**NOTICE OF A REGULAR MEETING
BONDURANT PLANNING AND ZONING COMMISSION
APRIL 28, 2022**

TITLE: -RESOLUTION NO. PZ-220414-12: Regarding recommended approval of the A-3 Auto site plan for an addition at 108 NE Hubbell Avenue

A3 AUTO SITE PLAN Bondurant, Iowa

SITE PLAN
A3 AUTO

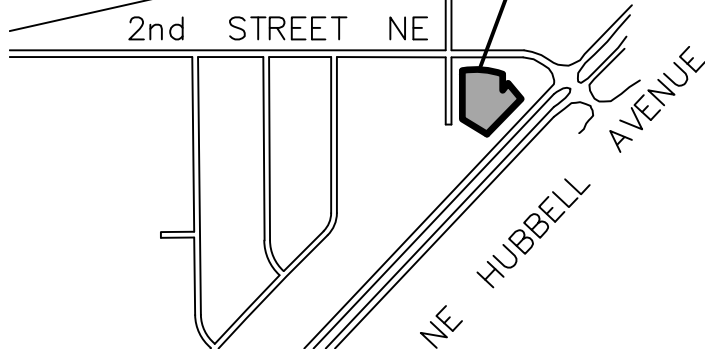
Parking/Drive Areas - the property is accessed via 2nd St NE and Pleasant St SE. Additionally, the property abuts Hubbell Avenue/Highway 65. As part of the City's 2019 site plan review and approval process, A-3 Auto was allowed to pave a portion of their driveway and parking lot on the City-owned land at Parcel 231/00072-002-005; this will remain unchanged as a result of this current project. Separate from this current site plan review process, staff will begin the research process to

The site plan has been updated to show a paved drive area leading back to the proposed addition area.

The site plan has been updated to show employee parking areas and also the ADA parking stalls.

Since this business opened in 2019, a new exterior dumpster is located on site. If an exterior dumpster will remain on site as a result of this project, the location shall be shown on the site plan. The site plan must also note screening proposed. Per Section 178.08.6.B.5 of the Zoning Code, an exterior dumpster must be fully enclosed in an enclosure similar in appearance to the principal structure. This has been factored in as part of the attached resolution.

1. That the applicant must submit a signed letter acknowledging that all Conditional Use Permit requirements of Section 178.08.6 of the Zoning Code, titled Design Standards for Auto Sales or Recreational Sales, will be met as a result of this request, with the exception of a 3-year temporary waiver of Section 178.08.6.B.9 relative to the curbing requirement of the current pavement area proposed due to the owner's plans for future paving adjacent to this current paving area.

4. That should the City Engineer request any additional stormwater management as a result of the updated site plan submittal, that this information be submitted for review/approval prior to beginning any pavement work.

3 Southwest Elevation
A104 1/4" = 1'-0"

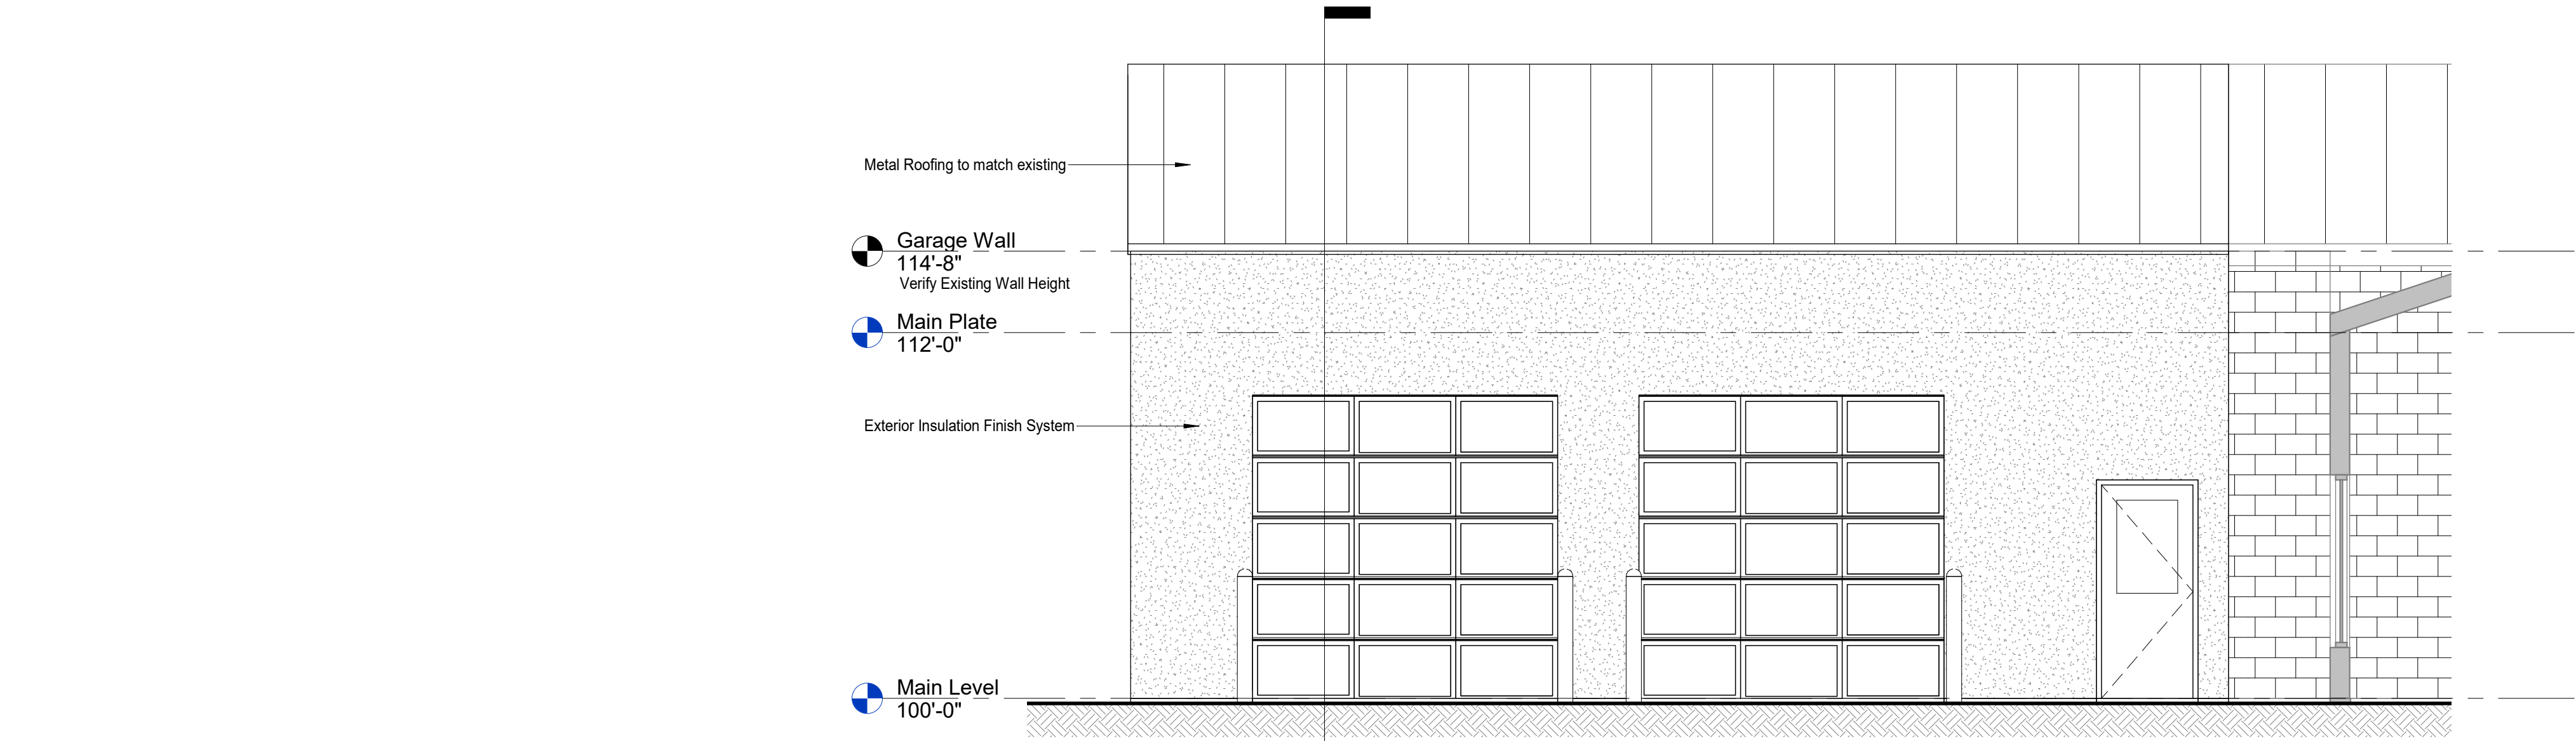
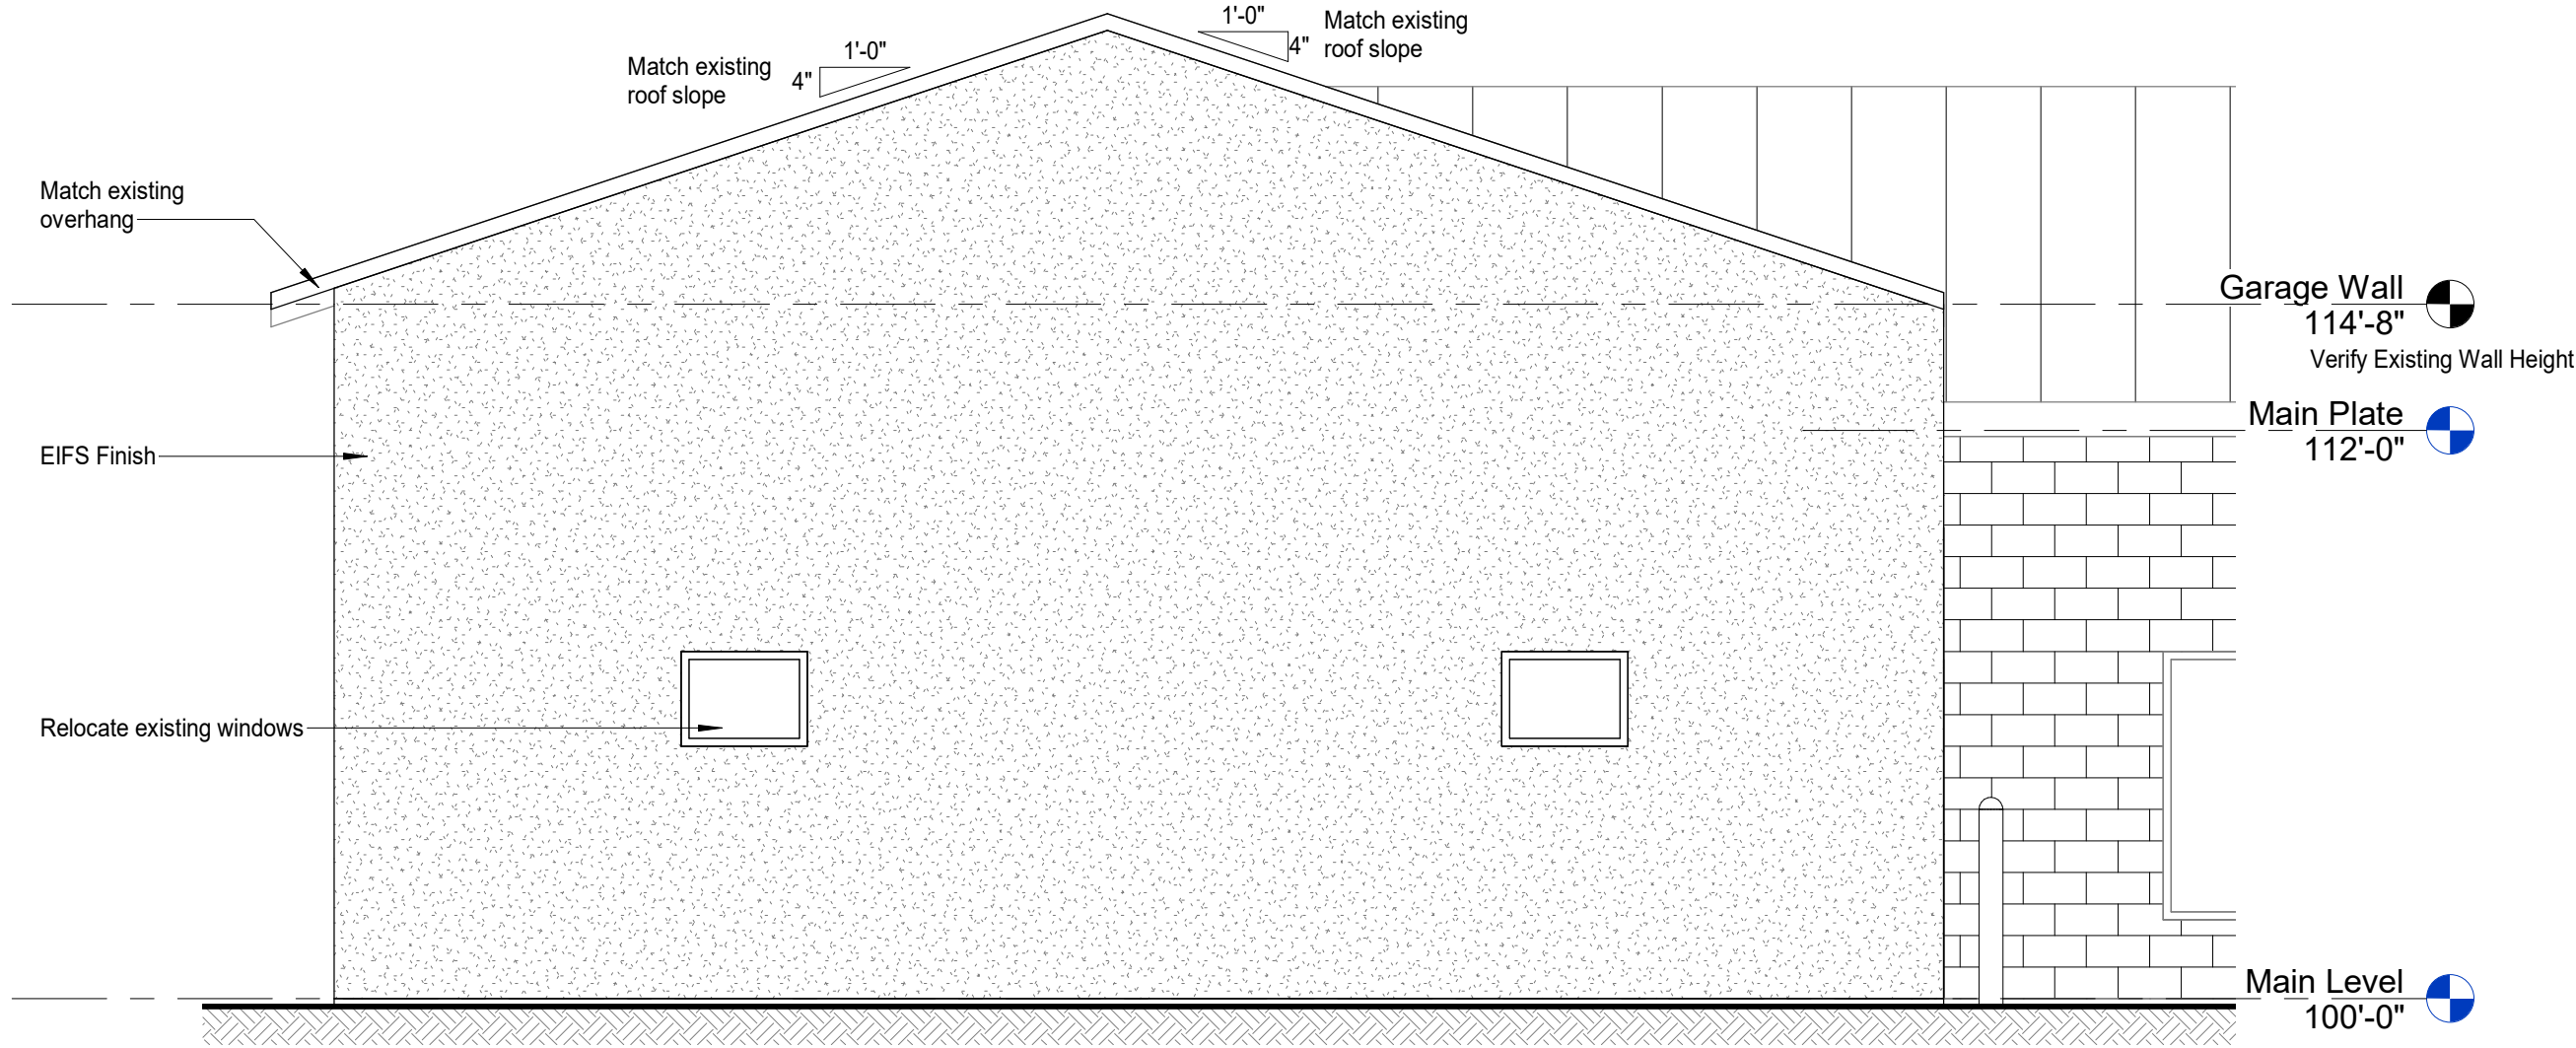
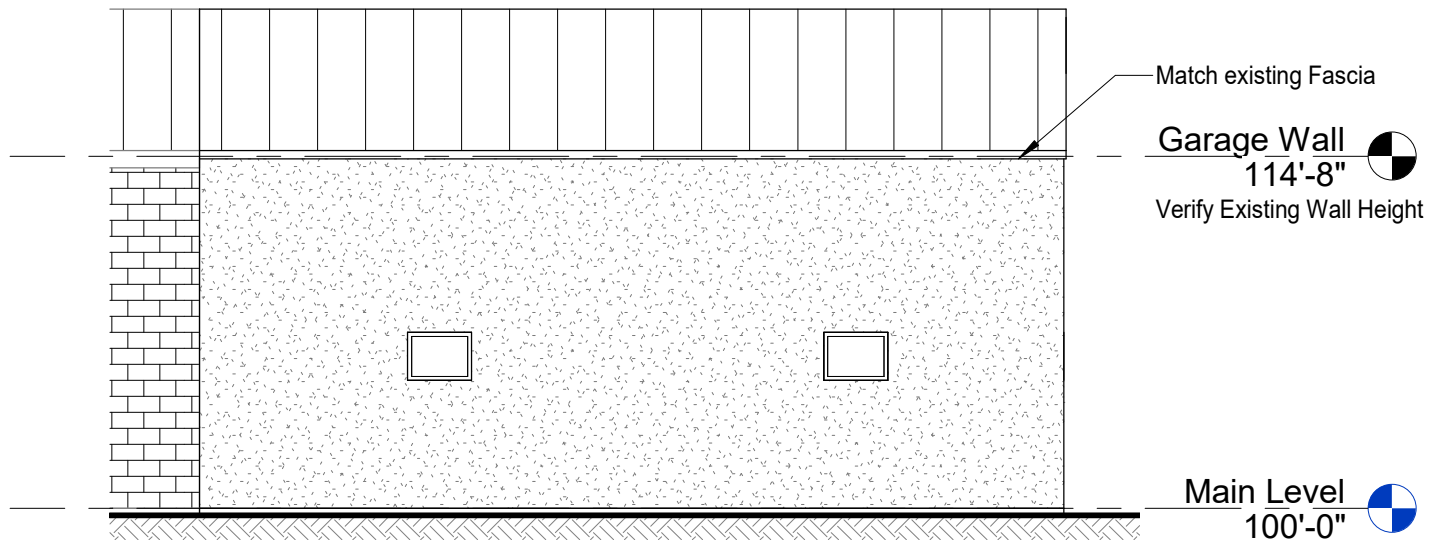
- Overhead doors shall not face the Highway 65 corridor if other positioning is available. *This item is met, as the doors face southwest toward the dead-end Pleasant Street SE.*

- Roof mounted mechanical units shall be screened from view of the public right-of-way. *The site plan acknowledges this requirement as being met.*
- All buildings shall be designed to minimize single plane walls and boxy appearance through the use of pitched roofs, dormers, cupolas, multiple rooflines, and relief in long wall expanses (179.01.2.1.6.a). *This item is met with the pitched rooflines proposed.*

- Commercial buildings shall incorporate facade modulation into all building elevations visible from the public right-of-way or adjacent less-intense uses in order to preserve building scale and reduce the effect of long, large, or expansive wall surfaces. This can be accomplished by physical offsets or the use of color, pattern, and texture (179.01.2.1.6.e). *This item is met through varying use of materials.*

- All public street-facing facades shall incorporate no less than 2 primary building materials together comprising no less than 50% of the total facade area of each street-facing facade. Limited building materials shall not be used on street-facing facades except as minor trim elements no to exceed 10% of each street-facing facade. *This item is met. All elevations include two primary/secondary materials for the entire facade areas (exluding the overhead door areas) - these primary/secondary materials are EIFS and windows.*
